### ADDENDUM NO. 1 - OUTLINE AND SUMMARY INFORMATION

Project Name: MSU Stadium Lots

PPA No.: 22-0012

Date: 03-27-2024

1 ELECTRICAL SITE PLAN -AREA 6  
EP2.6 1" = 20'-0"

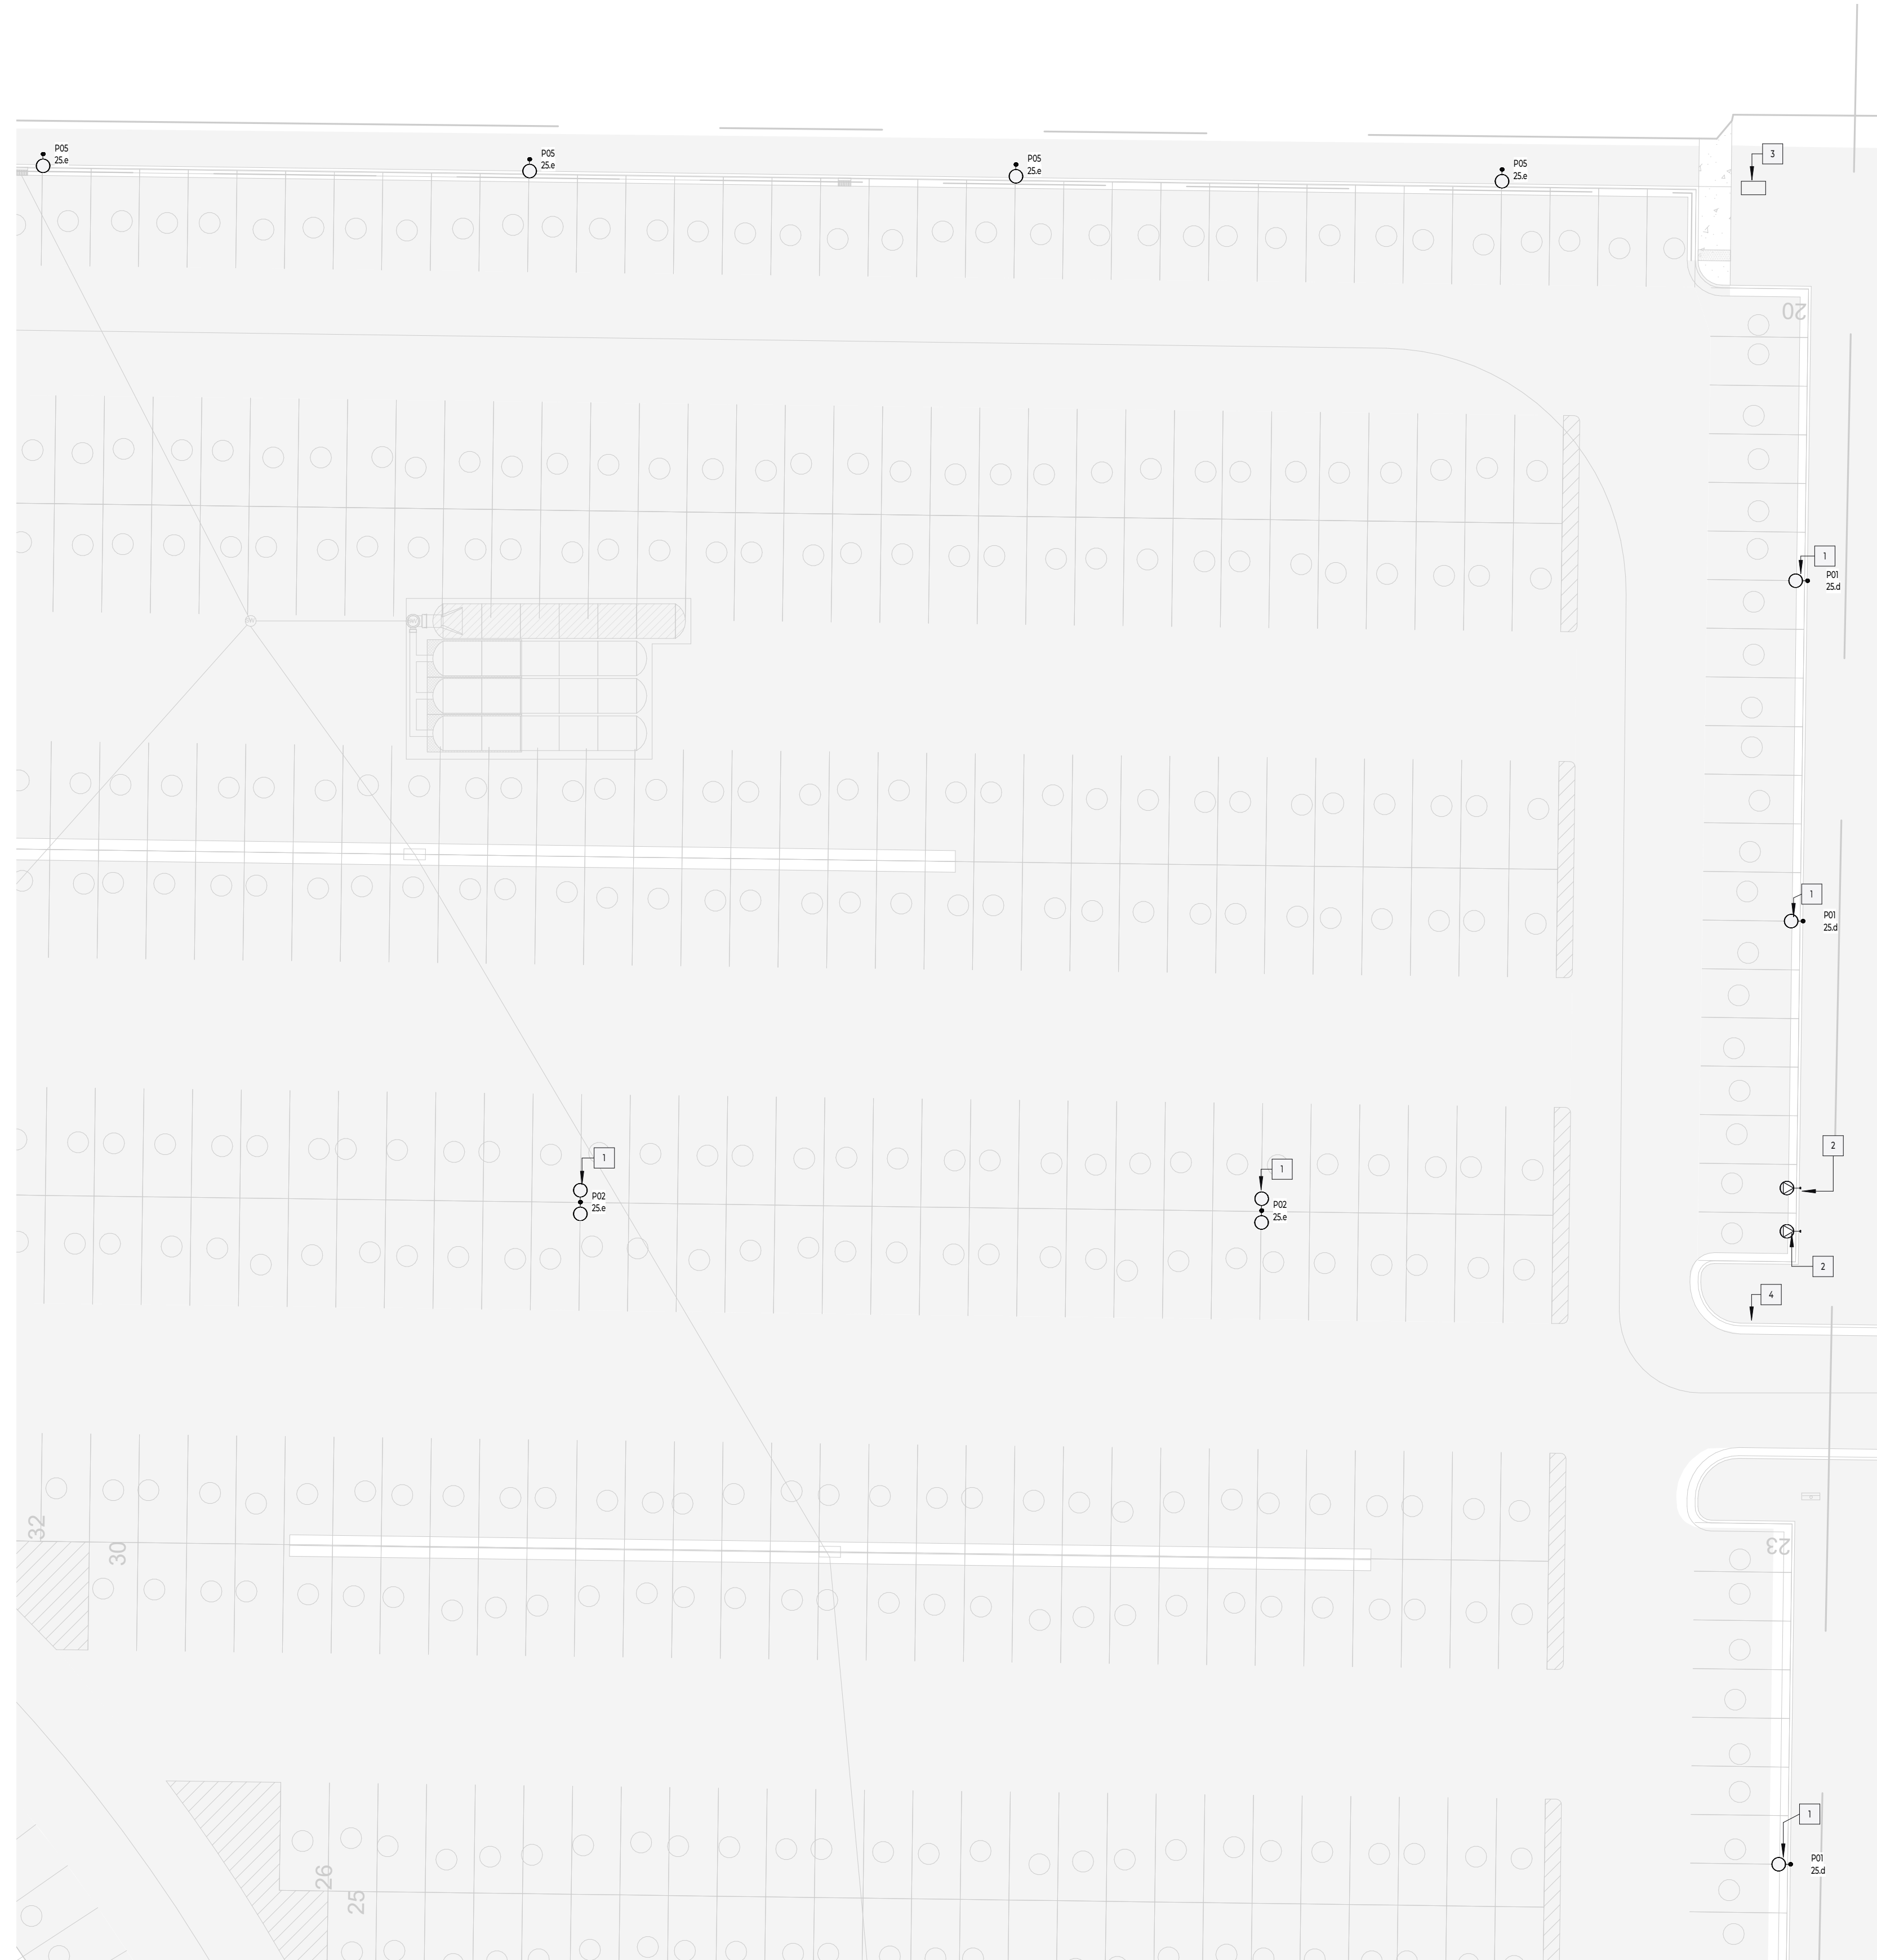
- A. REVISE – Revisions to sheet note 3 and 4.

1. New luminaire, pole and base.
2. Provide (3)#4(OAWG conductors & (1) #4AWG Ground in 2" conduit and connect to 50A breaker in panel LB for future EV charging. Provide handholes as required by article 100 of the NEC.
3. Provide Hubbell underground enclosure assembly for future access in case of rework. See E101 for details.
4. Provide 2" conduit under sidewalk for future use.
